February 28, 2017
BOARD OF COUNTY COMMISSIONERS
ORANGE COUNTY, FLORIDA
Y17-731-CC / ADDENDUM # 3
WITTENSTEIN COTTAGE ADA UPGRADES AND RENOVATIONS
Bid Opening Date: March 7, 2017

This addendum is hereby incorporated into the bid documents of the project referenced above. The following items are clarifications, corrections, additions, deletions and/or revisions to and shall take precedence over the original documents. Underlining indicates additions, deletions are indicated by ~~strike through~~.

4 RAILING DETAIL - TYPICAL
SCALE: 1" = 1'-0"

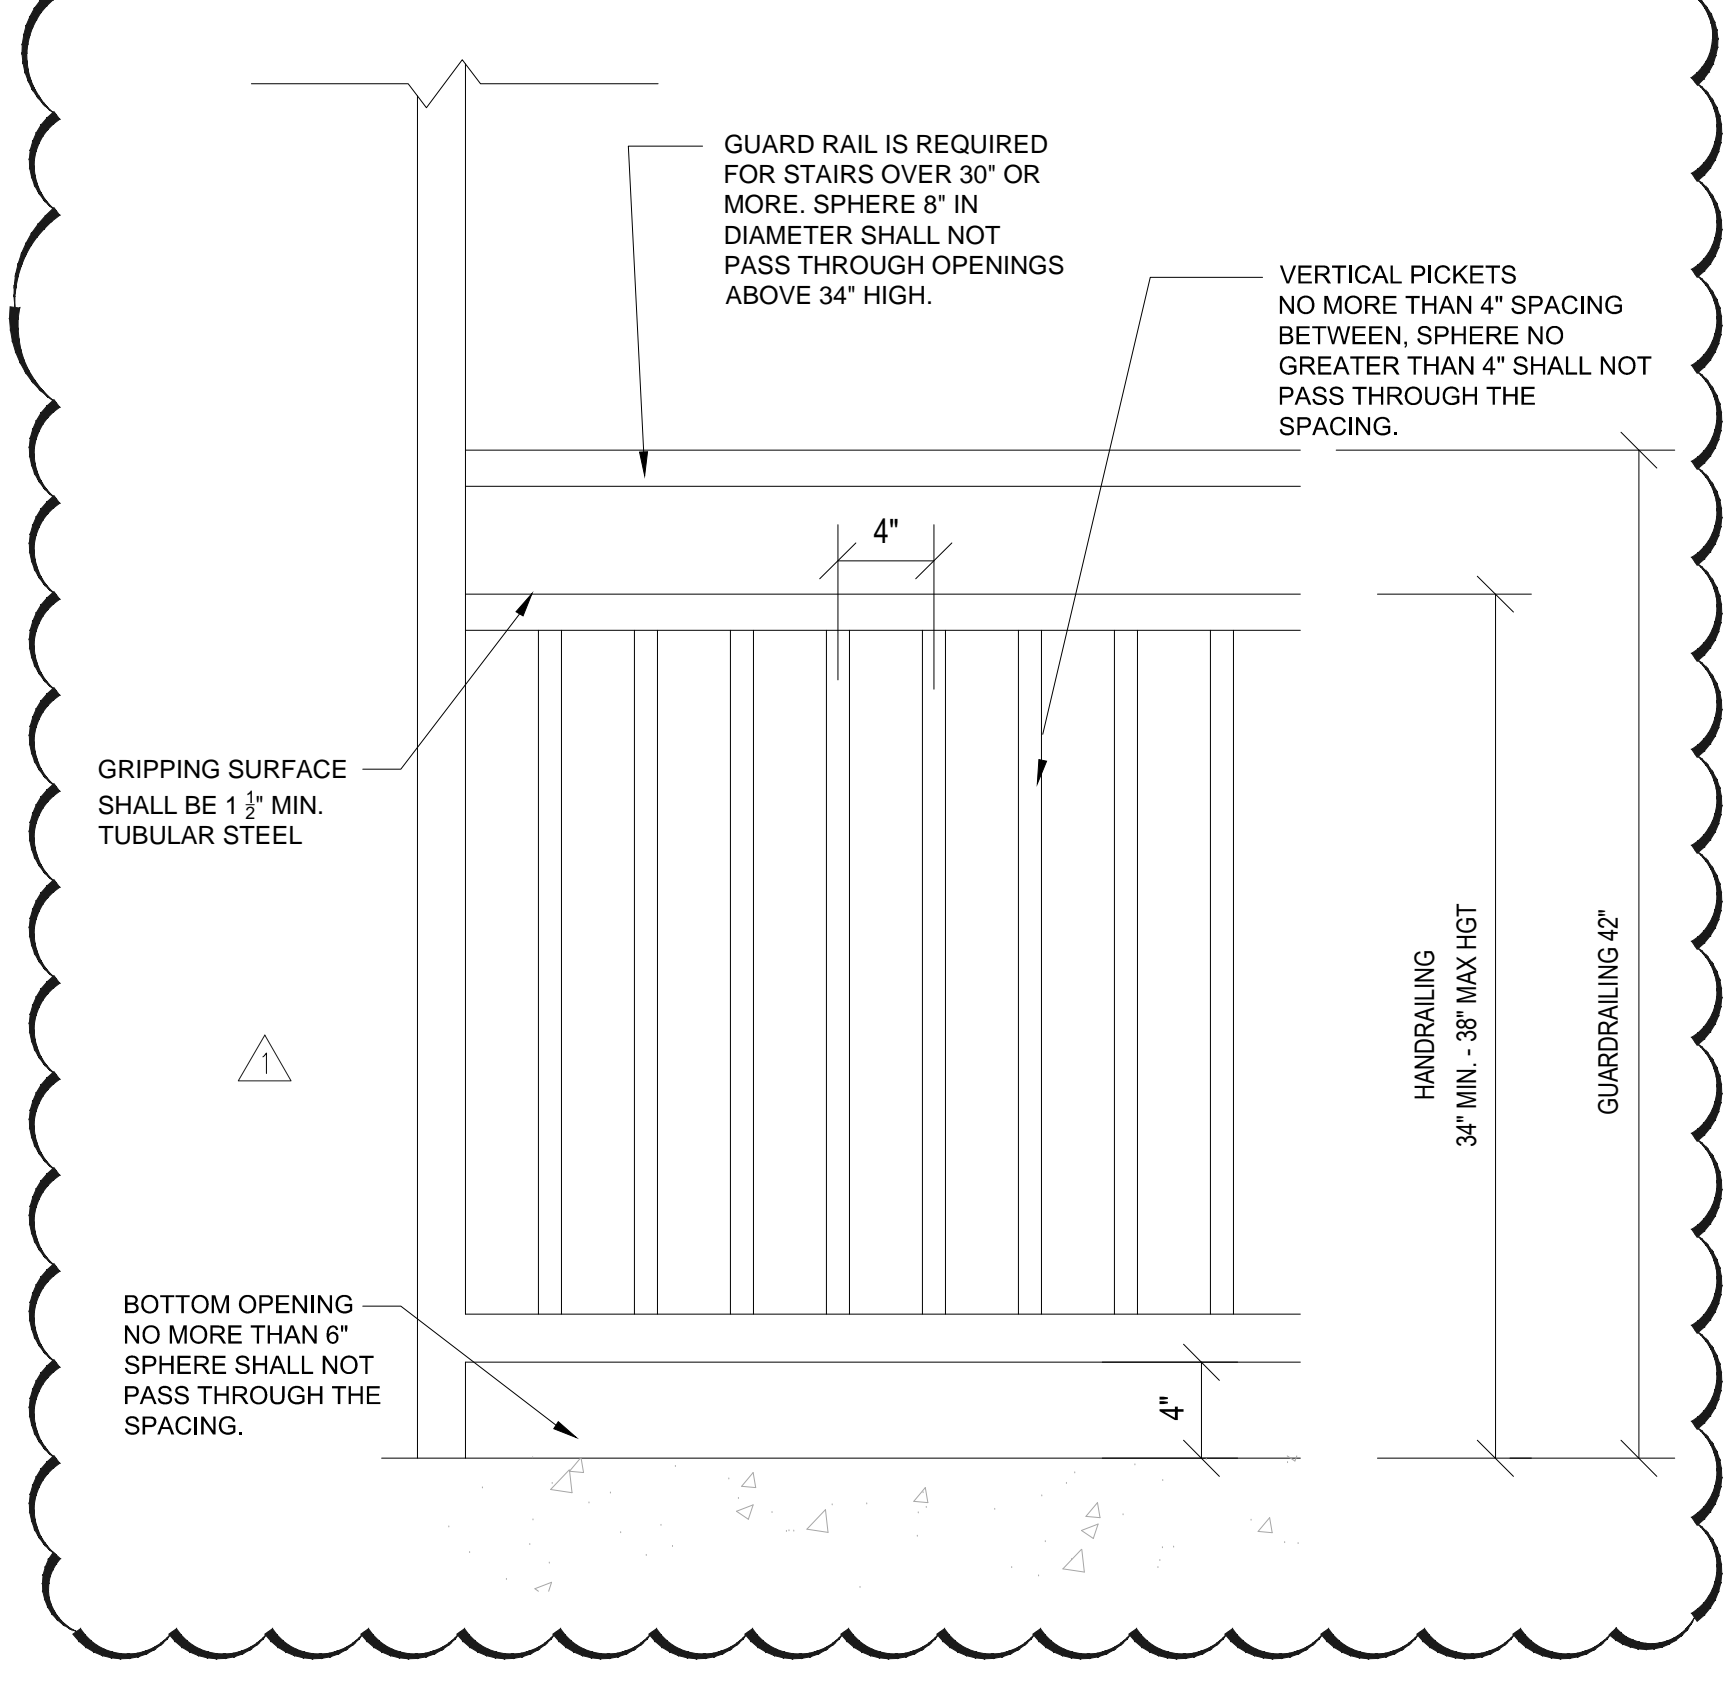
12. Question: Regarding the handrail details on A08.04, can FRP handrail be bolt-down in lieu of pocketed?

14. Question: The drawings call for tubular steel handrails on page A08.04 but the specifications contain only sections for Aluminum and FRP handrails. Which of these three options will be used?

Answer: No.

Answer: Aluminum or FRP handrails will be accepted, per specification manual.

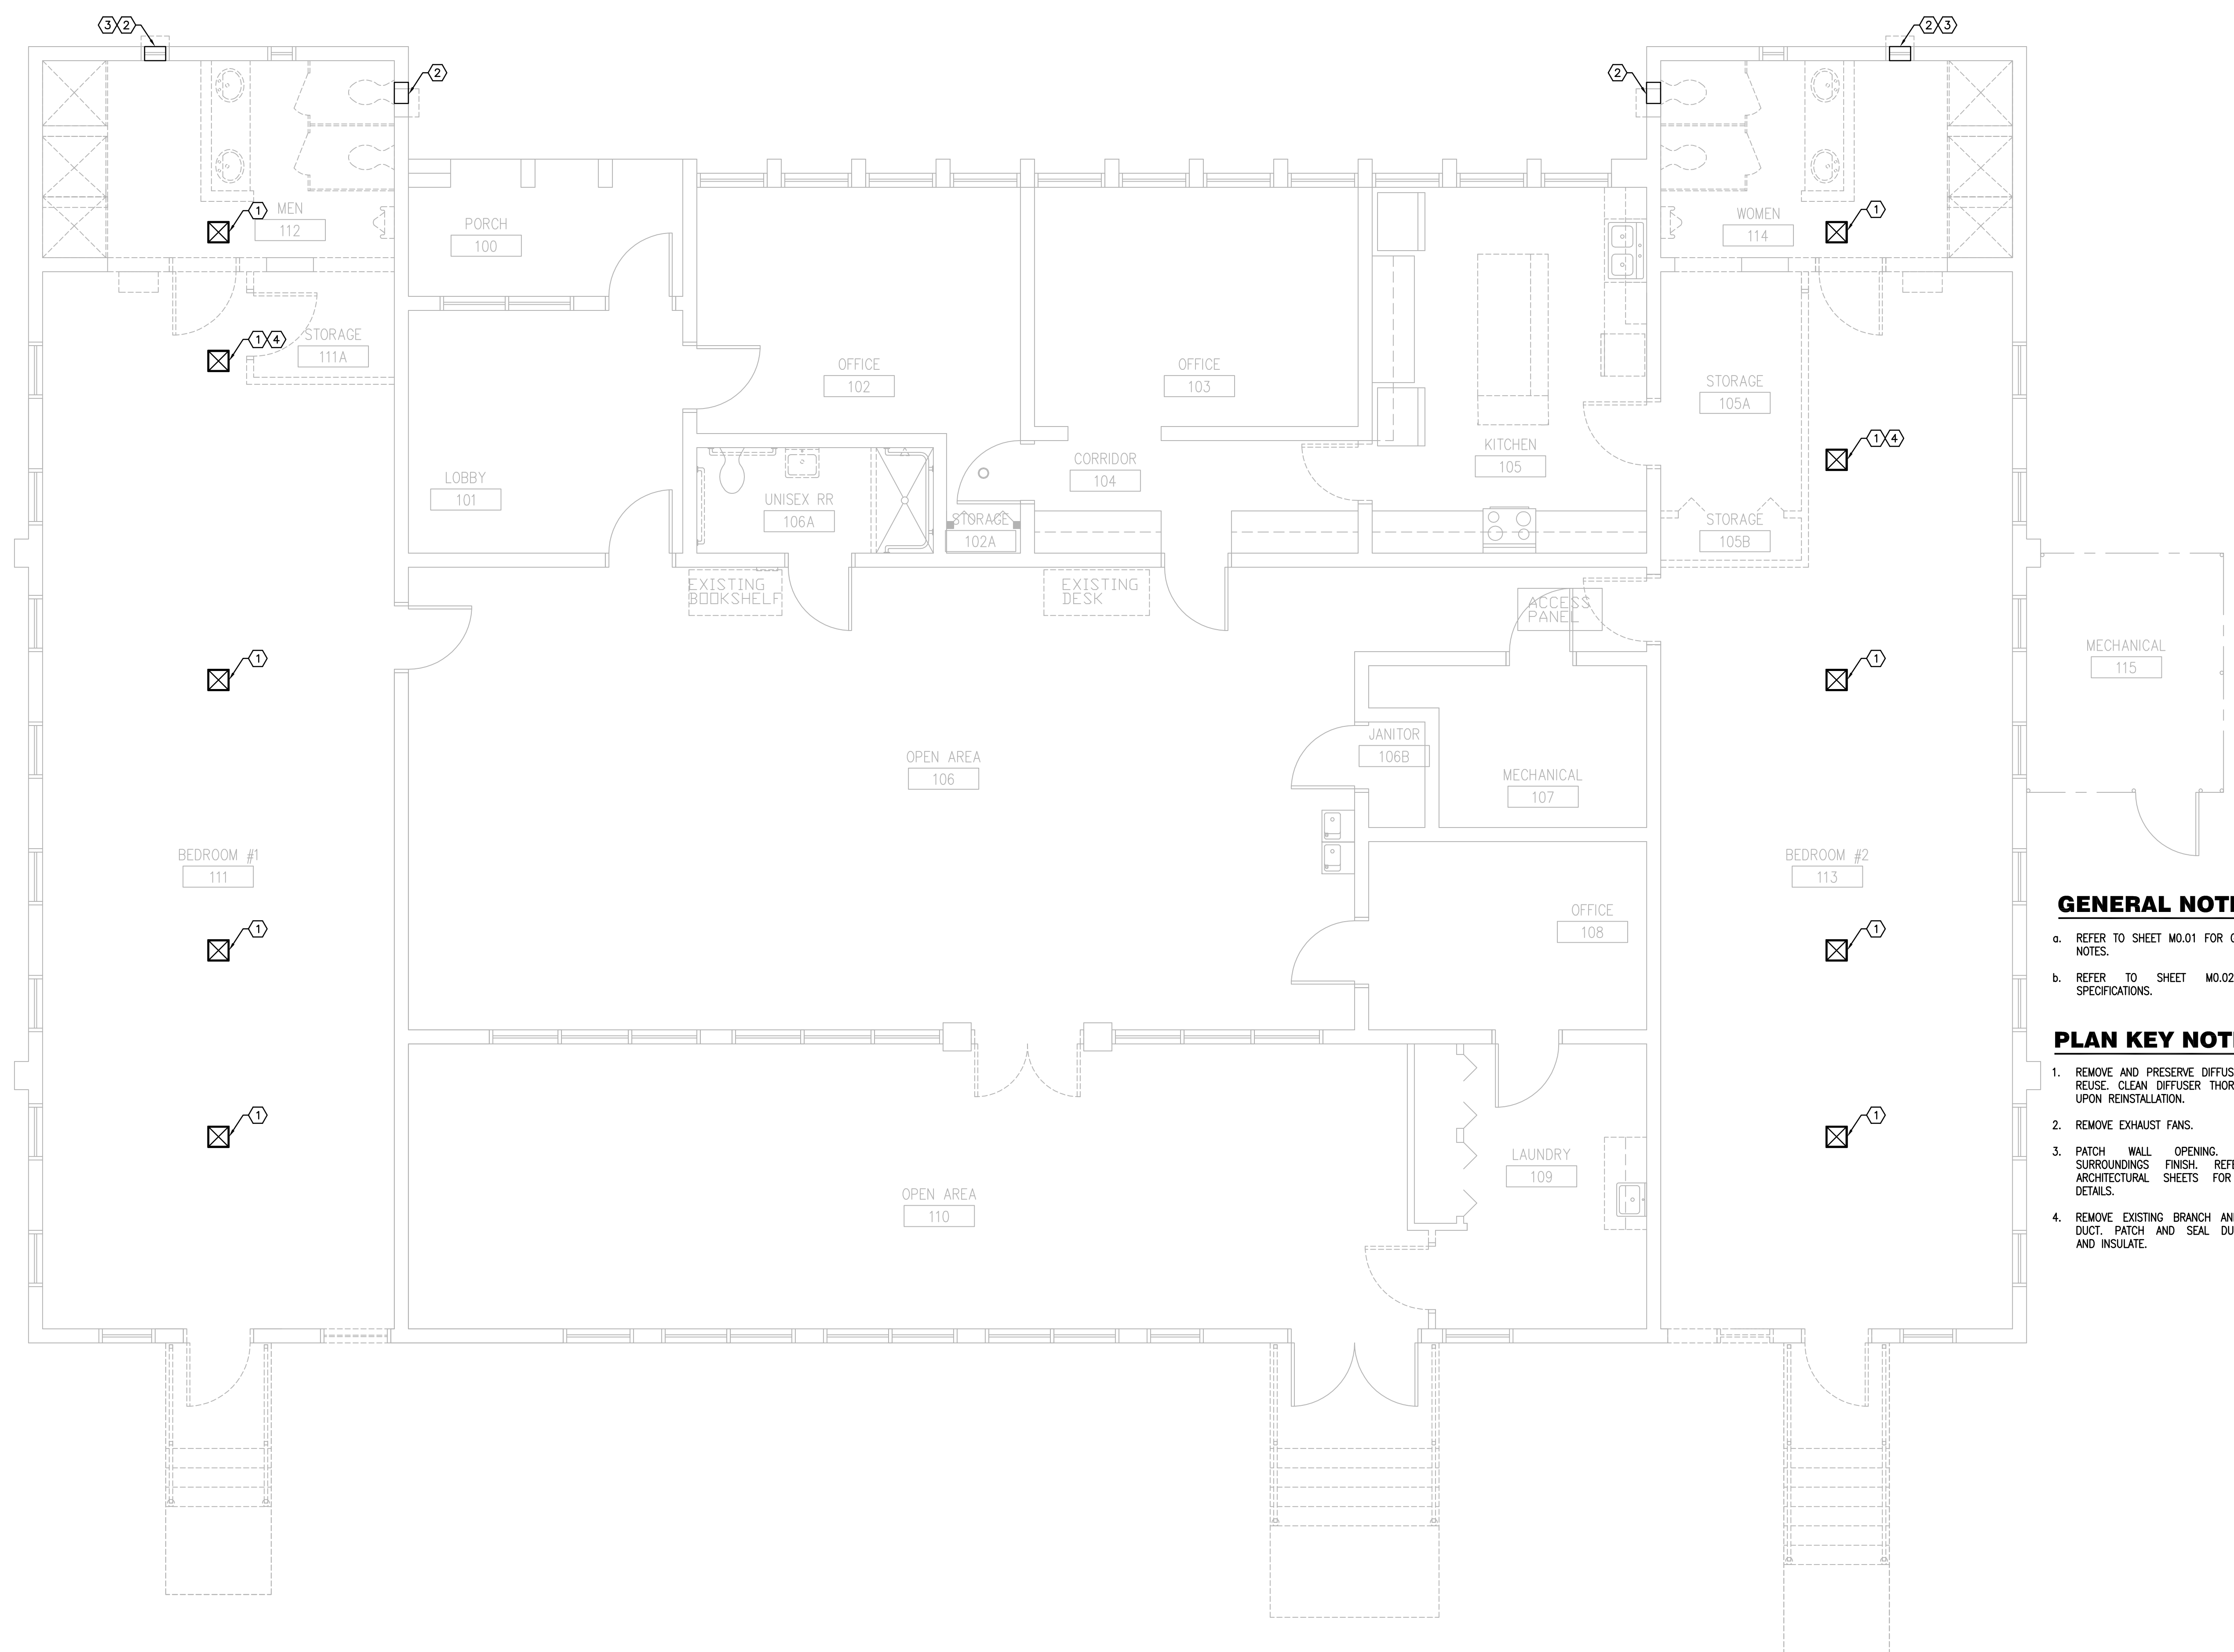
1. Question: Does Note 4 on Sheet MD 1.01 refer just to the diffusers that it is pointing to or is it meant to be a general note?

Answer: Note #4 pertains to the diffuser it is associated with. Refer to Sheet M1.01.

ED1.01

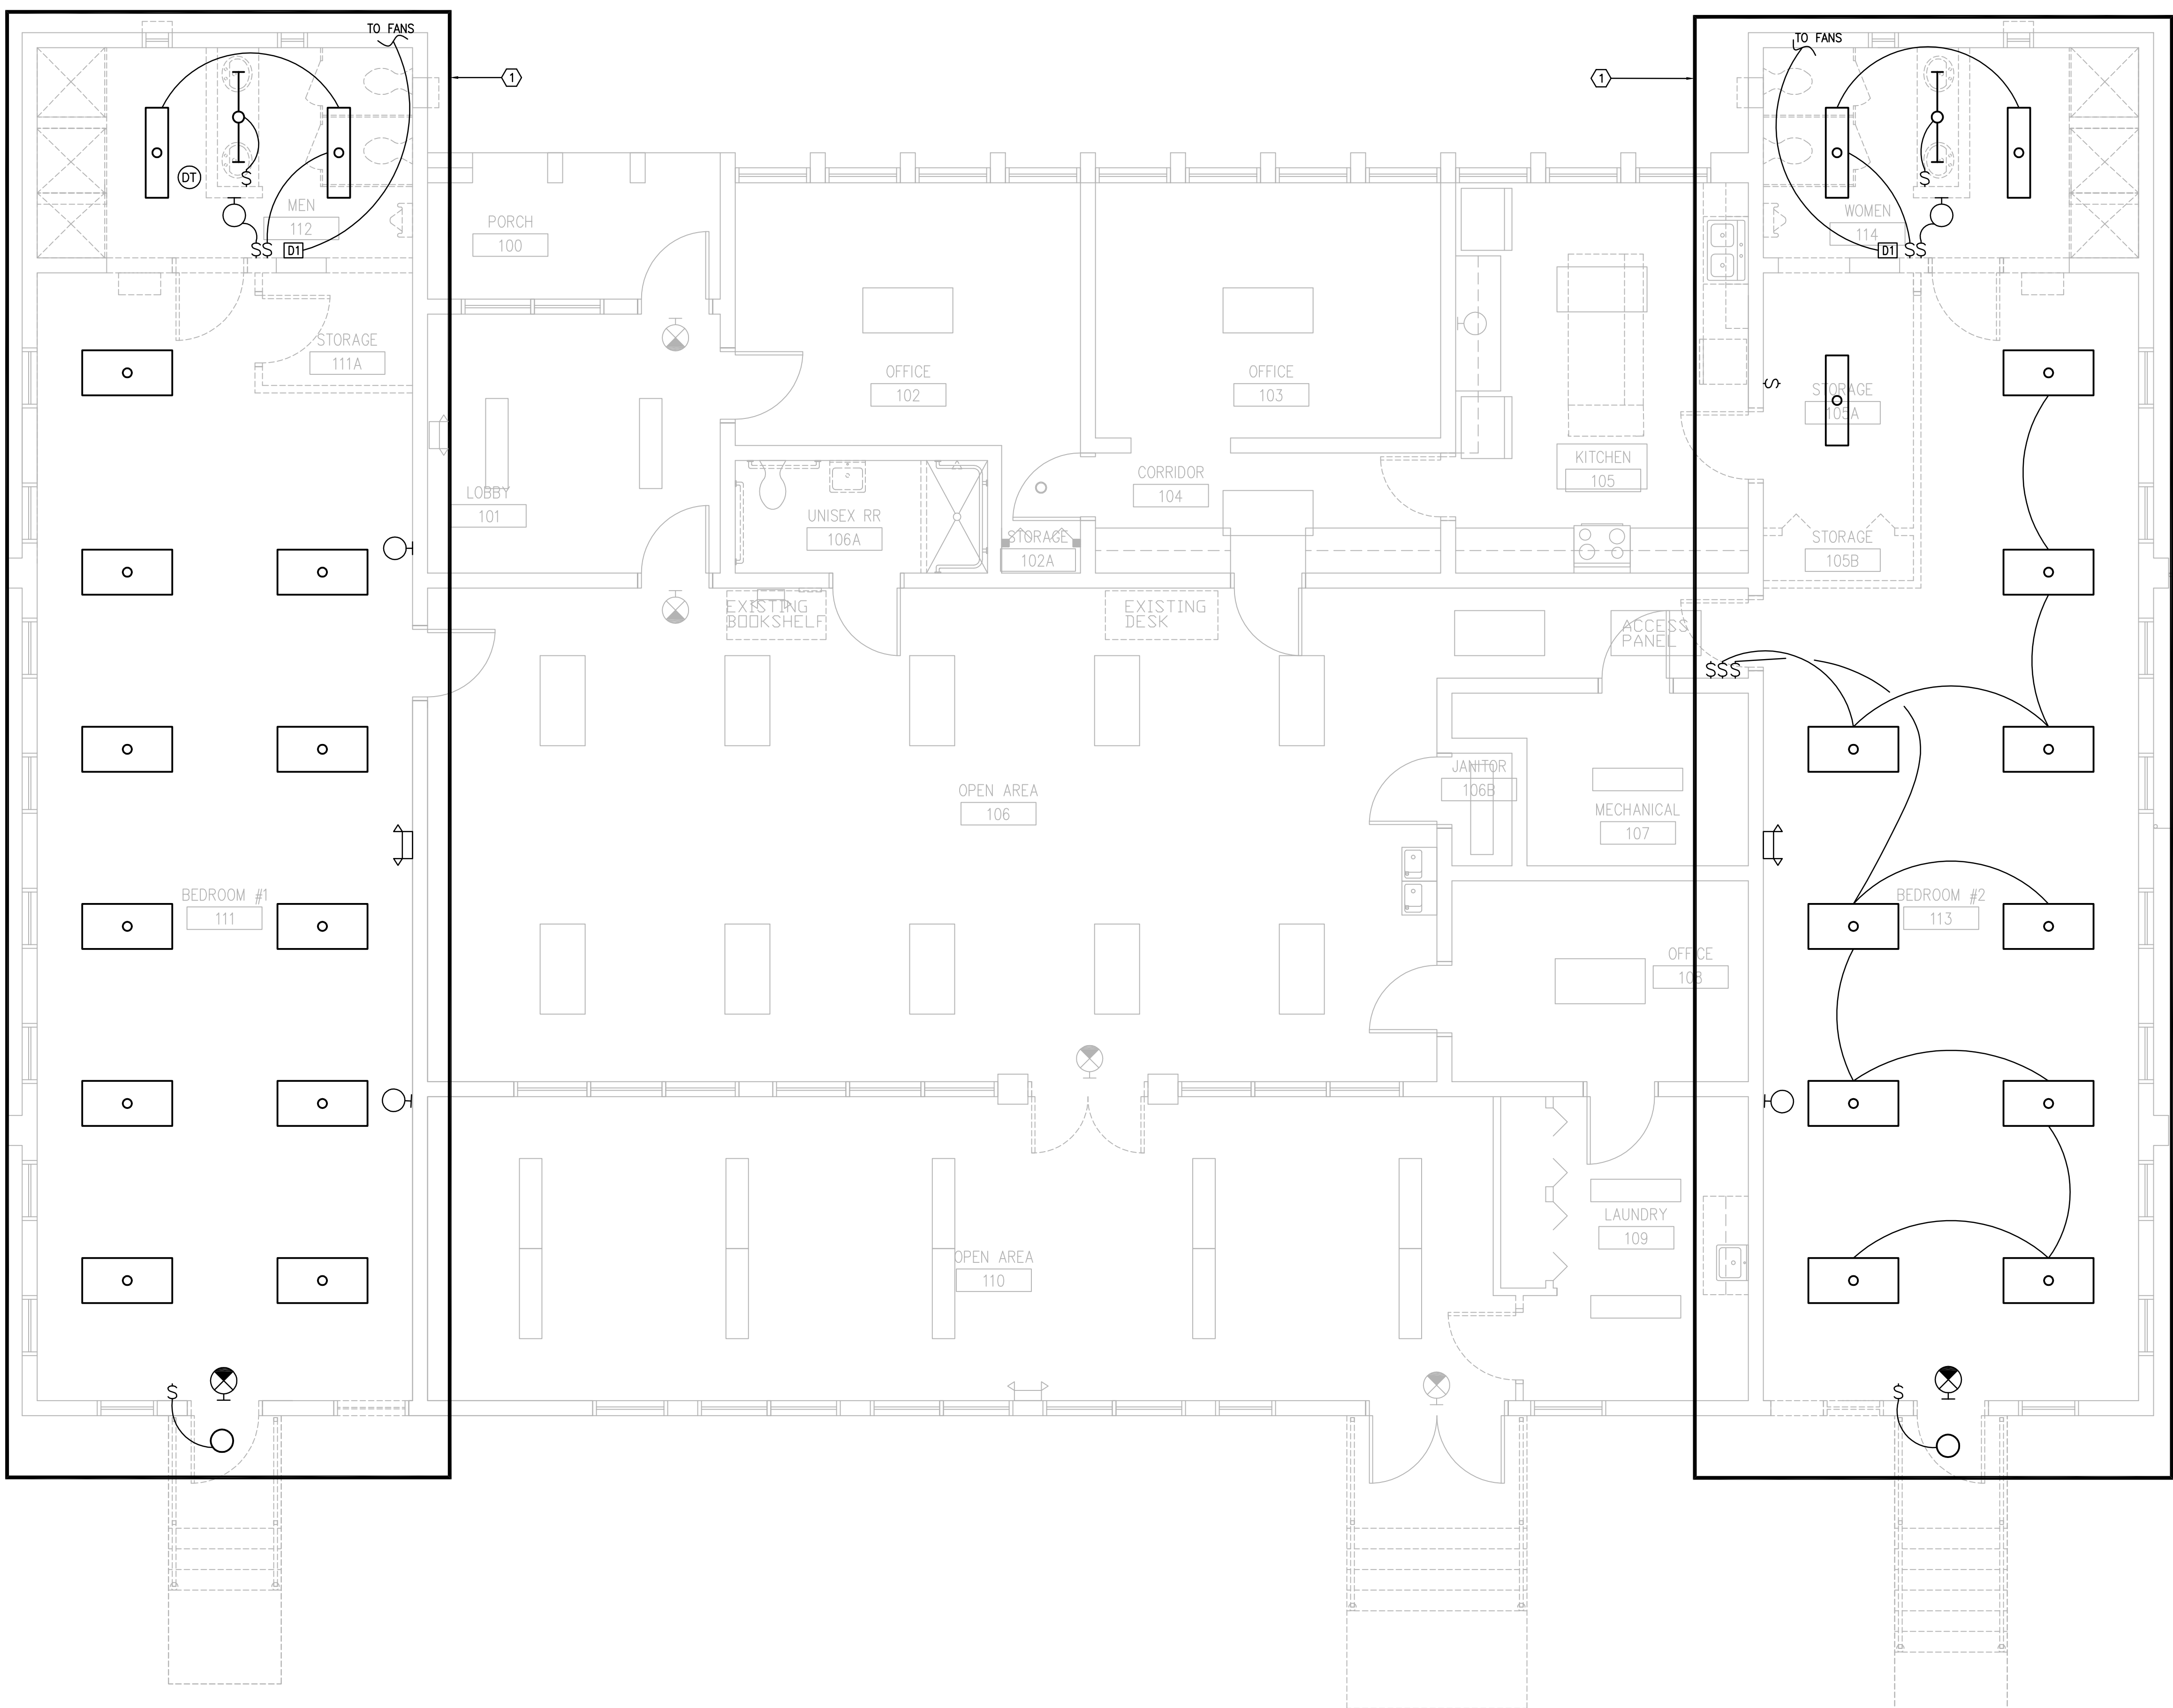
6. Question: At the walk thru, it was noted that there were light bulbs behind grilles on the interior walls of each bedroom (1 each). These lights do not appear on the drawings. Are they to be demolished and the holes closed with drywall?

Answer: Per attached Drawing ED1.01 Plan Note #1 the light fixture is to be removed. GC to patch and repair as needed.
